REMOVING THE EARTHING PIN FROM THE WELDED TUB CASING ASSEMBLY

EN	Publication number	599 72 70-44	Rev. 00	02/2010	dmm
----	--------------------	---------------------	---------	---------	-----

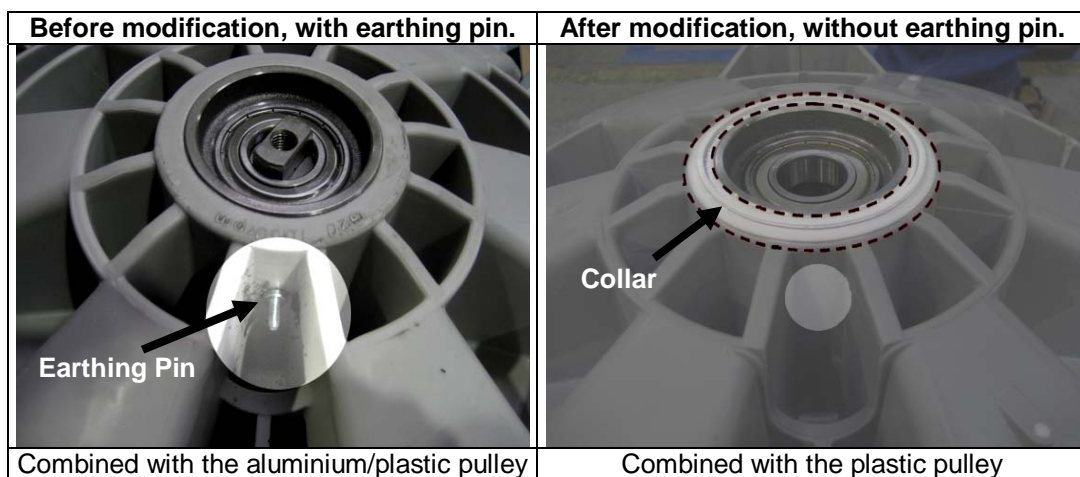
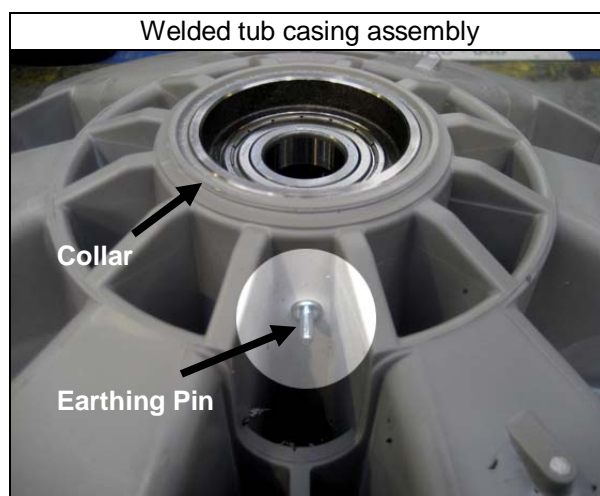
From Serial Number 003 xxxxx in all the welded tub assemblies, a collar has been created in the area around the hub and the earthing pin has been eliminated. As a result of this:

- the relevant wiring is removed and the plastic pulley is used.

The welded tub casing assembly, complete with rear casing fitted with collar and earthing pin, is supplied as a spare part and can be used on all appliances, as shown in the diagram provided on the table in the paragraph "service information".

SERIAL NUMBER

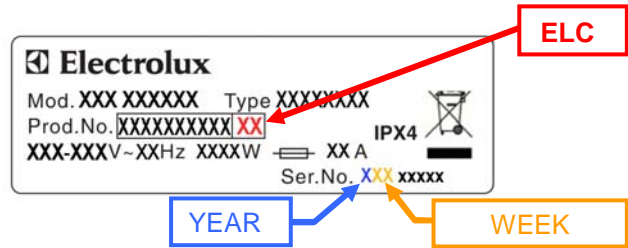
In production the models concerned by this modification will have a **new ELC** (see description of the serial number); for IKEA branded products pay attention to the **Serial Number**.

- Please check that the ELC corresponds to the spare parts list!
- In new appliances produced starting from Serial Number 003 xxxxx included, batches with ELC 00, fitting the aluminium pulley is strictly prohibited.

IKEA SERIAL NUMBER

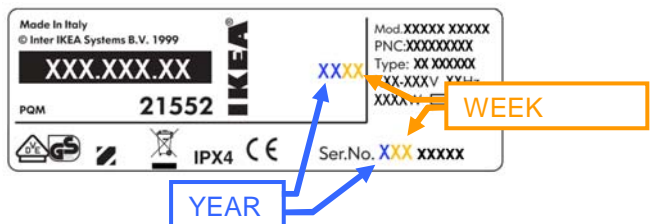
For IKEA models it is necessary to check that the Serial Number and the relevant spare parts list correspond.
